CITY OF LOS ANGELES

1201-1215 S Grand Av DOT Case No. CEN20-49737

UPDATED TRANSPORTATION ASSESSMENT FOR THE PROPOSED MIXED-USE PROJECT

LOCATED AT 1201-1215 SOUTH GRAND AVENUE AND 410 WEST 12TH STREET (CPC-

PROJECT SITE PLAN - GROUND FLOOR

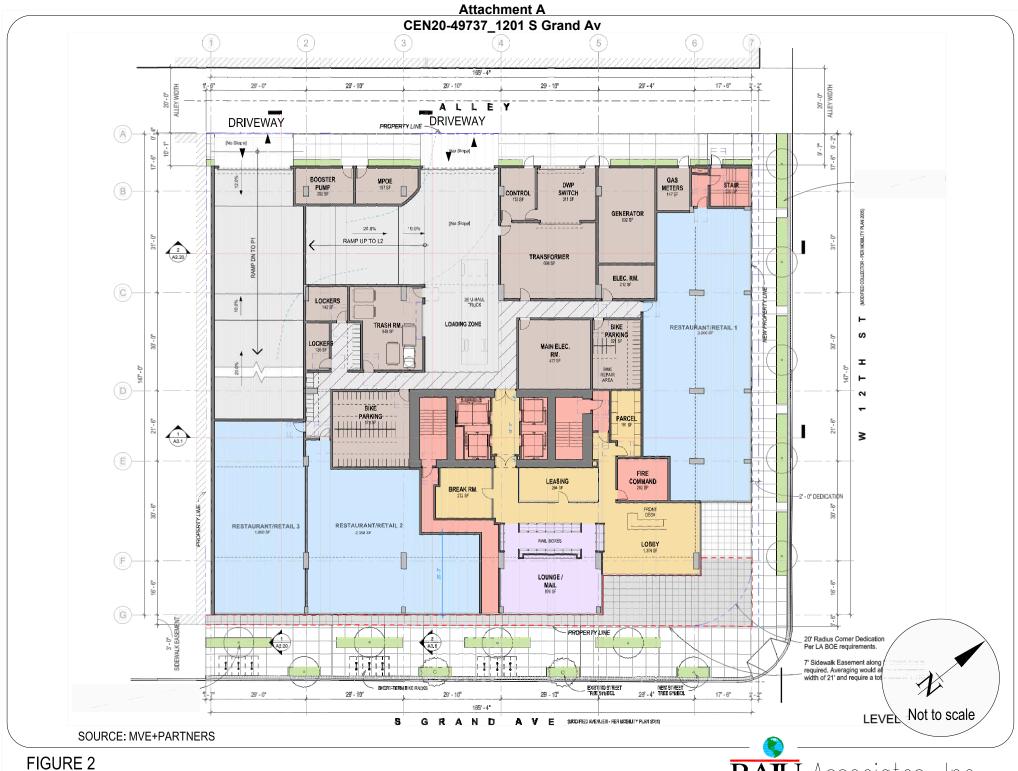
The conceptual site plan for the project (see **Attachment A**) is acceptable to DOT. The project would be accessed via the adjacent alley. Review of this study does not constitute approval of the dimensions for any new proposed driveway. Review and approval of the driveway should be coordinated with DOT's Citywide Planning Coordination Section (201 North Figueroa Street, 5th Floor, Room 550, at 213-482-7024). In order to minimize and prevent last minute building design changes, the applicant should contact DOT for driveway width and internal circulation requirements prior to the commencement of building or parking layout design. Driveway placement and design shall be approved by the Department of City Planning (City Planning) in consultation with DOT, prior to issuance of a Letter of Determination by City Planning.
